Re: Cherokee Nation WW Hastings Replacement Hospital - Addendum 02 Narrative

Following is a list of revisions included in Addendum 02.

PROJECT PHASE:
BID PACKAGE 02
(SITE DEMOLITION AND UTILITIES)

STORM DRAIN CONSTRUCTION NOTES

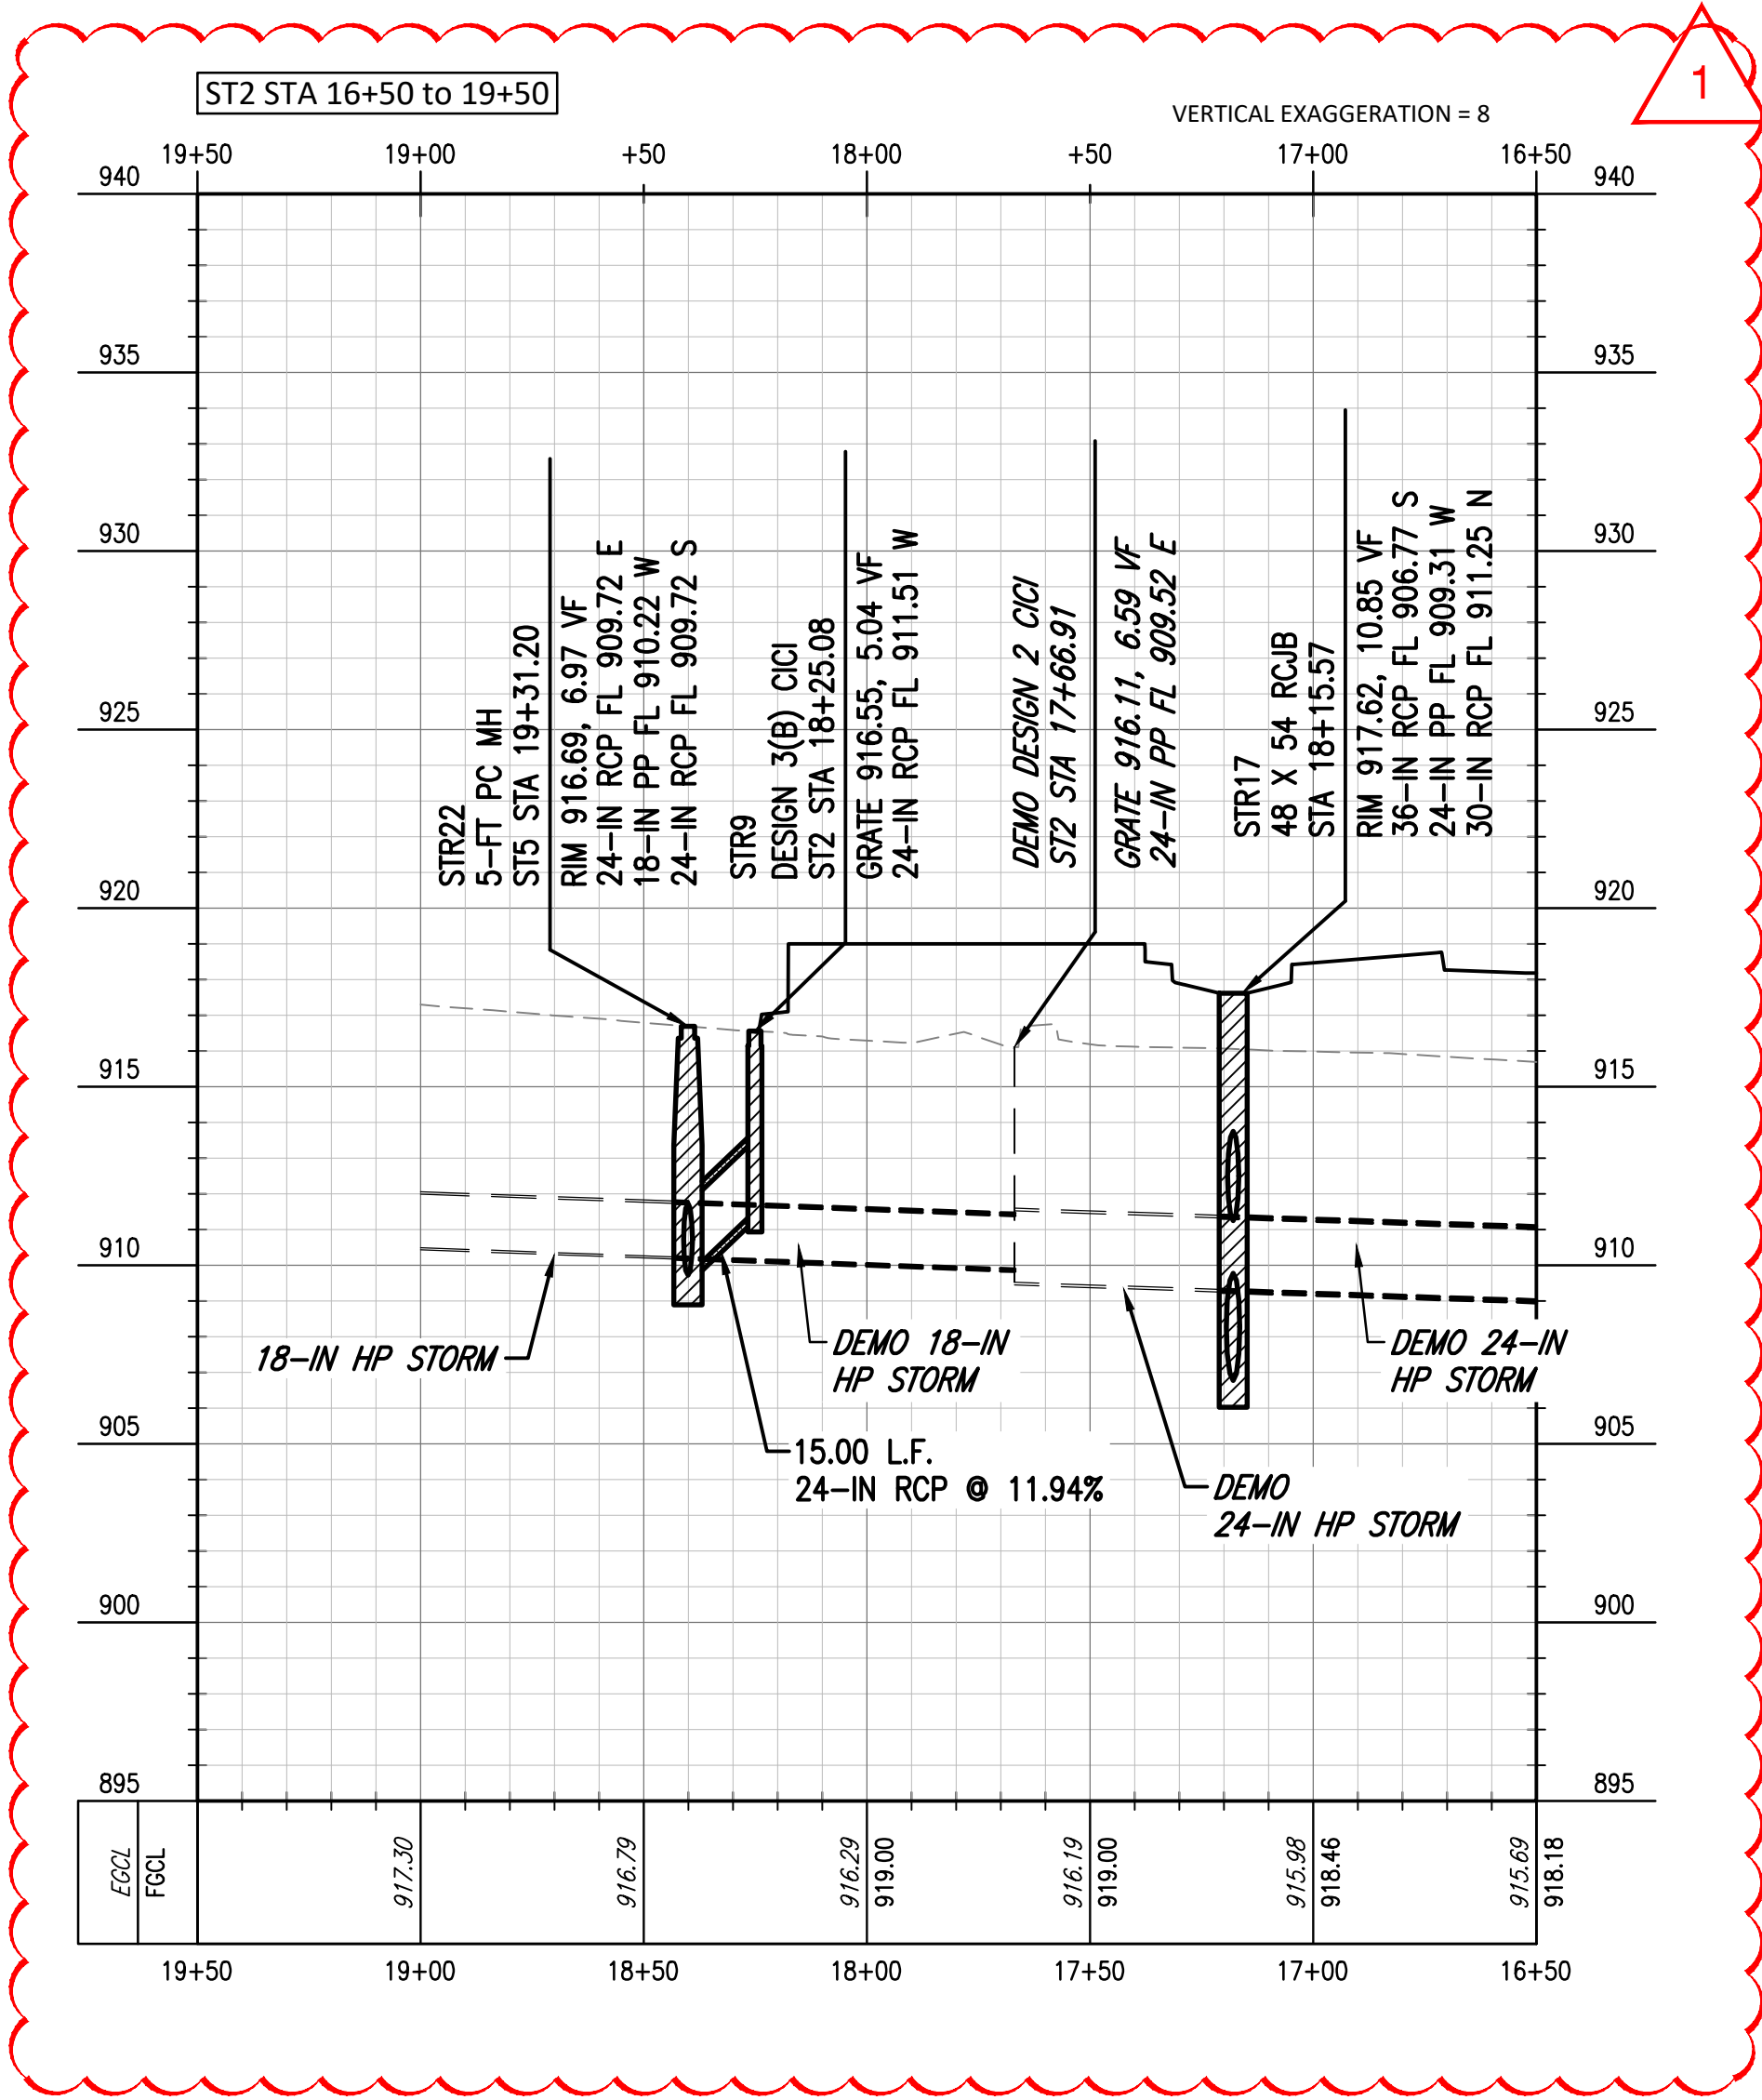
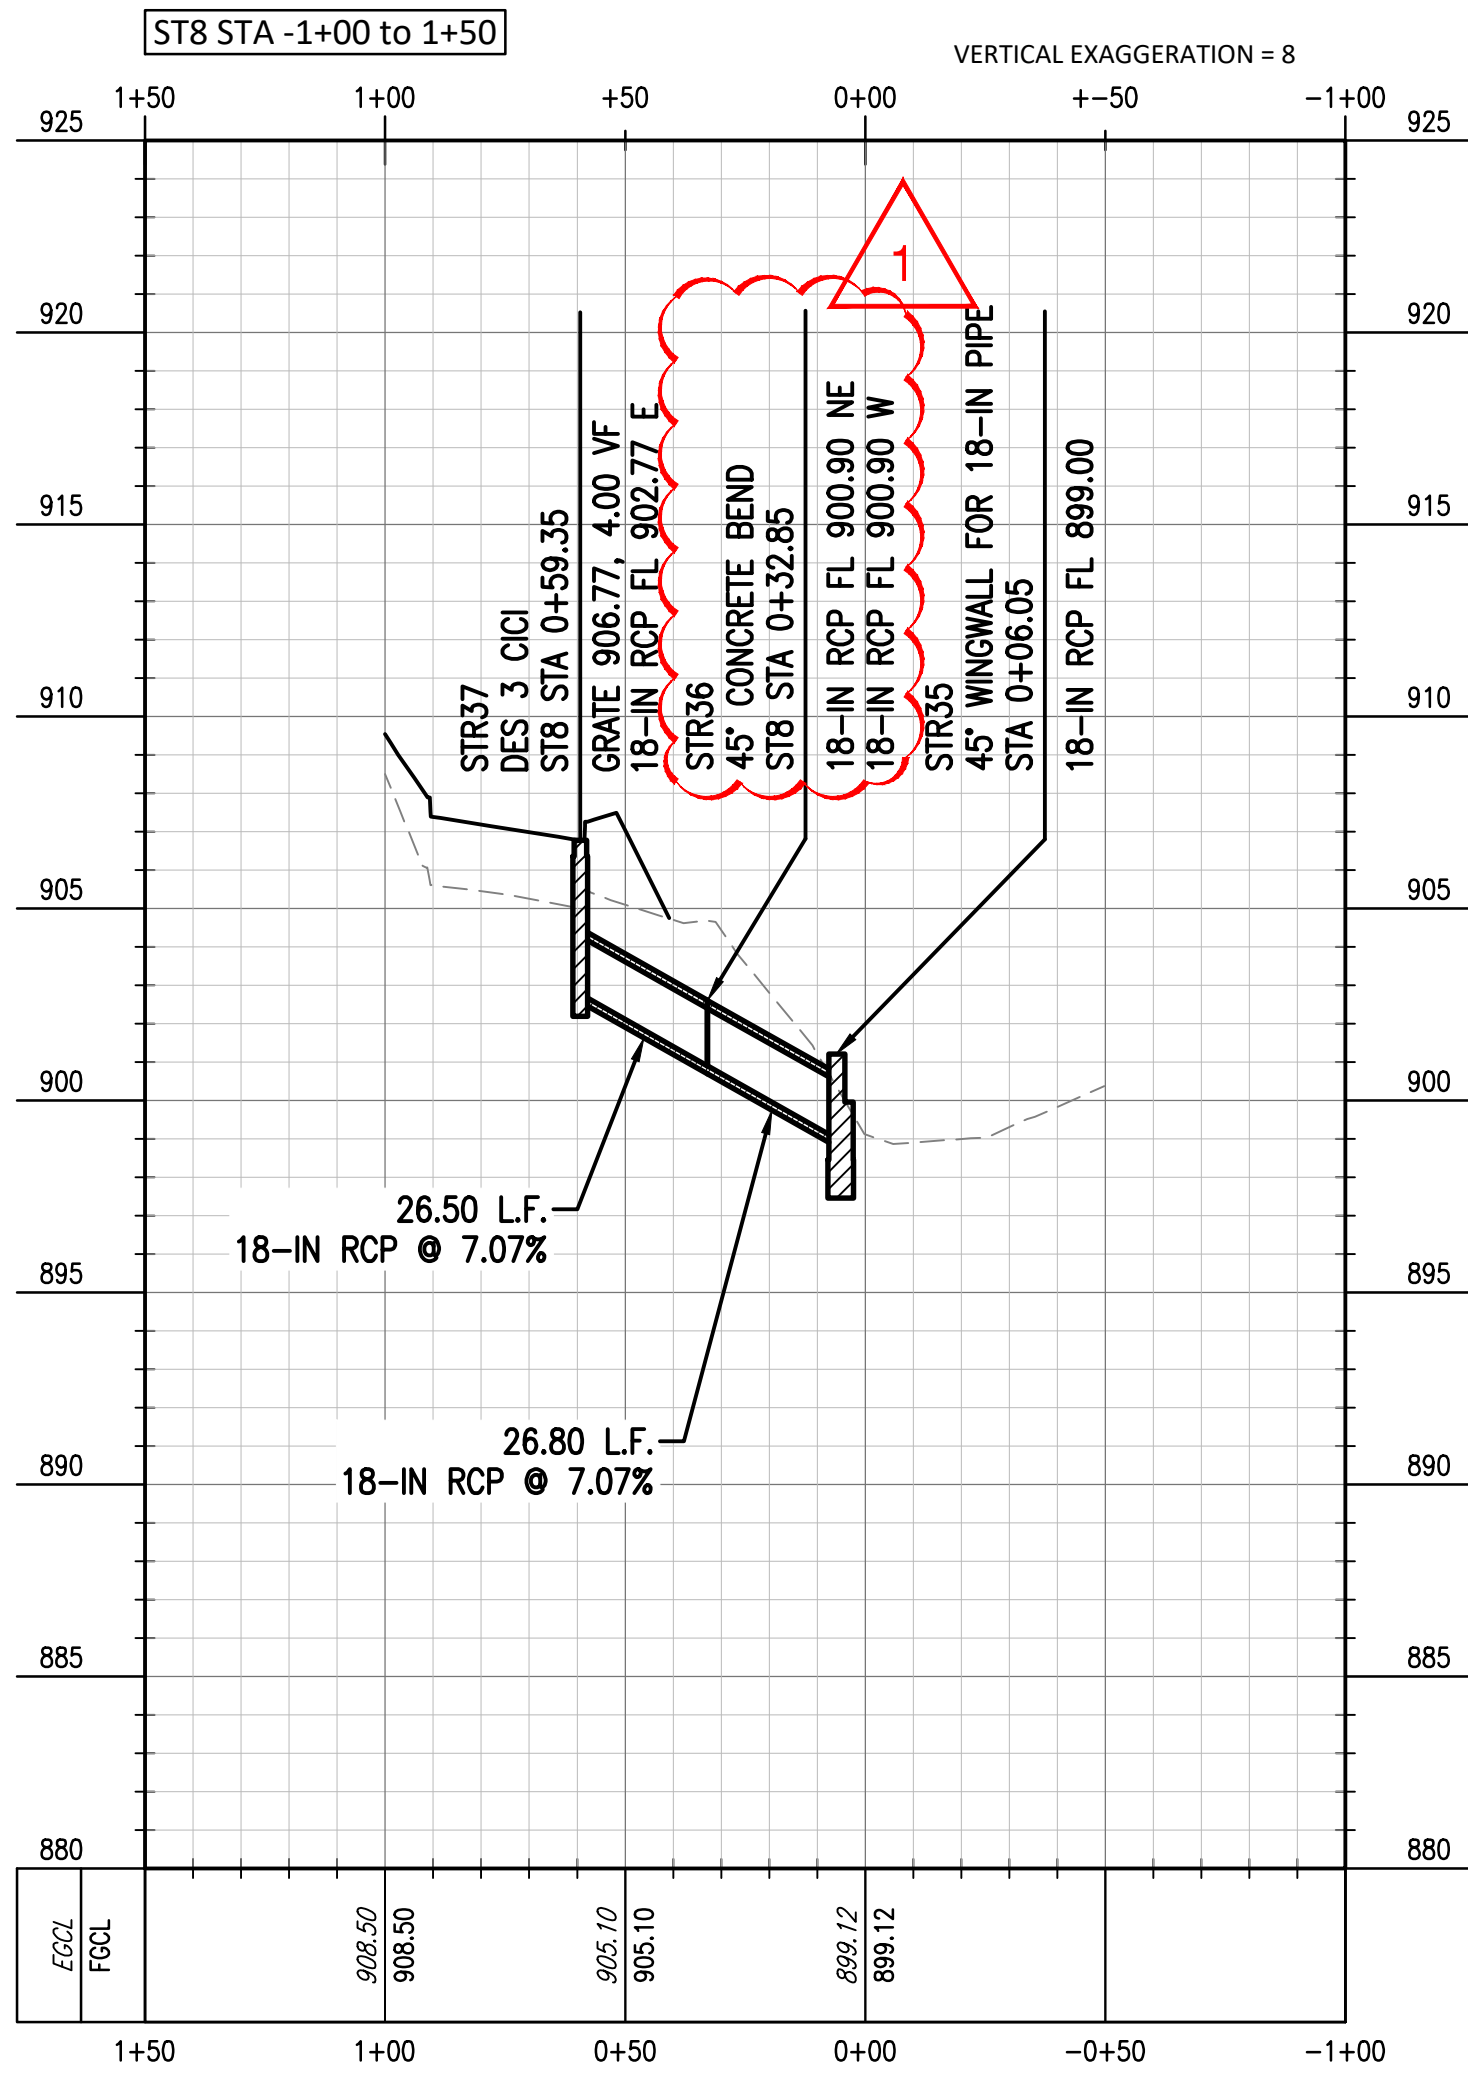
- C6-204 - Added label to STR17 in ST6 profile.
Added label to 45 deg bend in ST8 profile.
Added profile for ST2 to provide a profile of the existing storm sewer to remove from under the Central Energy Plant.
The storm sewer in ST7 profile was lowered so that drainpipes on the upstream end can pass under the 16-in water line.
Added STR38 to ST7 profile.
The pipe from STR33 to STR30 was lowered to pass under the 16-in water line.
